DRAWING TITLE  
BLDG 2 THIRD FLOOR PLAN - AREA G2

PROJECT TITLE  
SLVHCS REPLACEMENT MEDICAL  
CENTER PROJECT

2AI103-G2

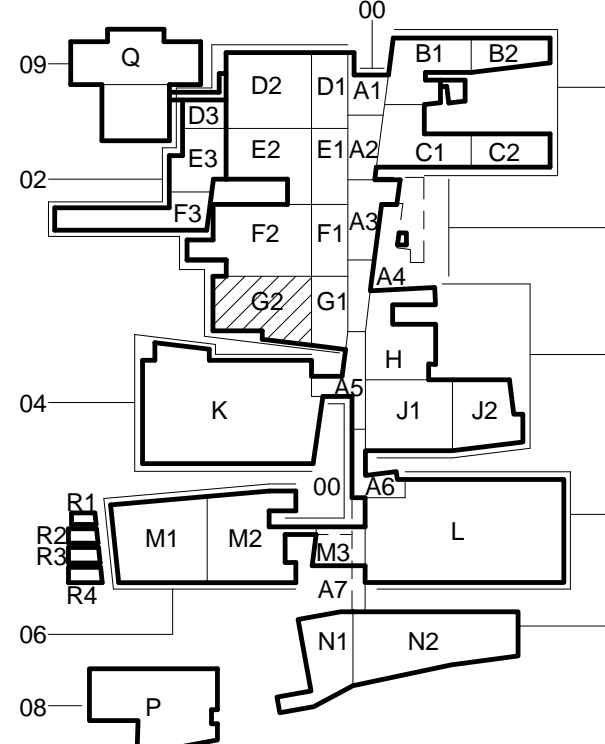
All noted PD's & CR's on this page were either added, removed, clarified or relocated per RFI 04695

RFI 07212 and 07212.1: All exterior walls where J-4 walls were deleted and more than 3/4" of fire safing is exposed to be handled per RFI.

RFI 06254: Female Staff Lockers

RFI 02082: A 6AC

RFI 07435: Install D24A or P24A wall and align with electrical closet.

RFI 0584: Shaft wall to be coordinated to fit duct risers

RFI 04422: Marker board 6'-4" from West wall to C/L

RFI 02966.1: TPO

RFI 03037: Fire retardant casework required.

SEE RFI 05314: Shifts wall and sink 20" North to accommodate foot pedals and bedpan washer

SEE RFI 02746 - EXPAND COLUMN WRAP 3" EAST TO ACCOMMODATE 6" GW RISER

REFER TO THE FOLLOWING SKETCH FOR CHANGES: SK-8-4-NJ 2AI003
